# Service Campaign Bulletin

Campaign No. 2020120012 December 2020

SUBJECT: **Model 907 Model Year 2020**  
**Retrofit Lock Nut on Exhaust System**

D49.10-A012-76

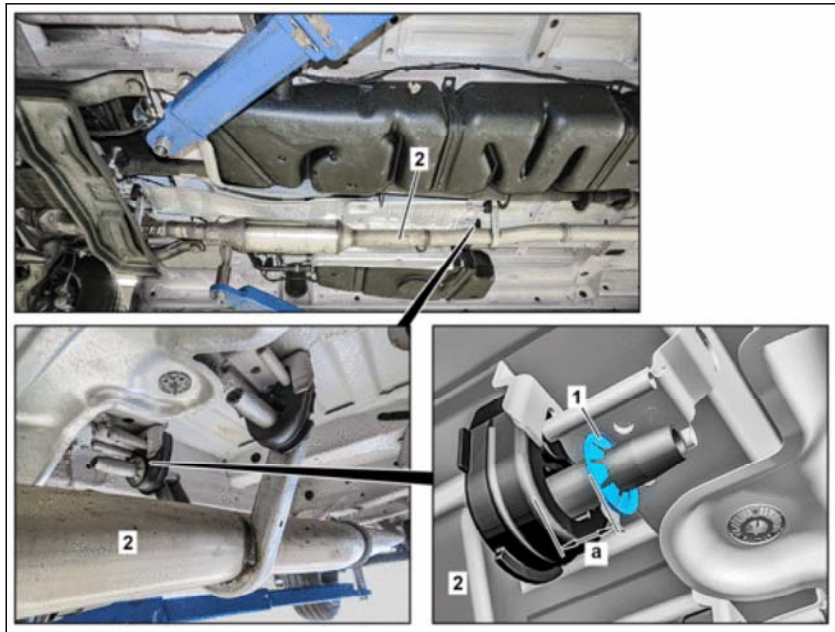
MBAG, the manufacturer of Mercedes-Benz and Freightliner Sprinter Vans, has determined that the lock nut may not have been installed on the holder of the exhaust system on some vehicles. As a result, the exhaust system may move beyond the tolerance threshold, especially in the case of extreme load changes or other higher loads during vehicle operation. The purpose of the fixing ring is to increase the level of robustness throughout the vehicle's life cycle.

- 1 Spring nut
- 2 Exhaust system
- a Dimension (15 mm)

<b>Check</b>		
1	Check, whether the vehicle is affected by the measure.	 For authorized Mercedes-Benz service partners, only the entry in the Extended VEGA Application (EVA) system, in the "Current" tab, is decisive. An additional test of the affected vehicles in the workshop information system (WIS) or vehicle list is thereby not necessary.	
	<b>Install</b>		
2	Raise vehicle. Special instructions for lifting and supporting vehicle		AH00.60-N-0100-01TS AR00.60-D-1000-04TS
 AR			
3	Retrofit lock nut (1) to holder of exhaust system (2).	 Make sure that the dimension (a) between the lock nut (1) and decoupling element is observed.	
4	Lower vehicle.
